Access Compliance Report

Public Rights-of-Way (Curb Ramps)

Intersection ID: 53147	Main Street: ACHIEVEMENT_LN	Cross Street: NEW_RENAISSANCE_WY	Location: SW
ADA ID: 3C656EEC4D93	Ramp Type: Directional1	Initial Pass/Fail: Fail	Overall Compliance: No
		Severity Score: 1.25

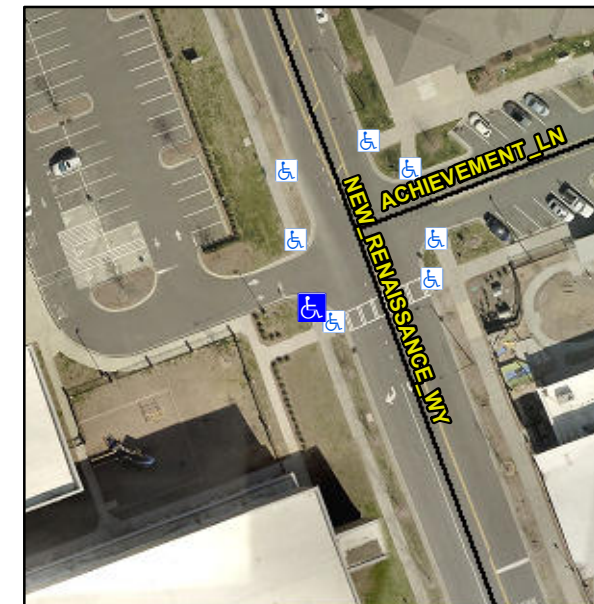
R304.5.3

Compliance	Description	Data	Compliance	Description	Data
N/A	Ramp Length (in)	72.0	N/A	Grade Break?	N/A
Yes	Ramp Width (in)	70.0	N/A	Grade Break Slope (%)	0.0
Yes	Ramp Slope (%)	8.2	N/A	Grade Break XSlope (%)	0.0
No	Ramp XSlope (%)	4.3			
N/A	Flare Type LT	N/A	N/A	Flare Type RT	N/A
N/A	Flare Slope LT (%)	N/A	N/A	Flare Slope RT (%)	0.0
N/A	Flare Traversable LT?	N/A	N/A	Flare Traversable RT?	N/A
N/A	Landing Length (in)	0.0	N/A	DWS Provided?	N/A
N/A	Landing Width (in)	0.0	N/A	DWS Contrast?	N/A
N/A	Landing Slope (%)	0.0	N/A	DWS Length (in)	N/A
N/A	Landing X Slope (%)	0.0	N/A	DWS Full Width?	N/A
N/A	Landing Curb? (Y/N)	N/A	N/A	DWS Offset LT (in)	N/A
N/A	Shared Landing?	N/A	N/A	DWS Offset RT (in)	N/A
N/A	Gutter Ponding?	0.0	N/A	Gutter Slope (%)	N/A
N/A	Gutter Lip Ht (in)	0.0	N/A	Gutter X Slope (%)	N/A
N/A	Painted X Walk1?	No		Road Slope (%)	1.1
	X Walk 1 Direction	To NW		Road X Slope (%)	0.8
	X Walk 1 Width (in)	N/A		Clear Space?	N/A

Remove & Replace Entire Ramp.
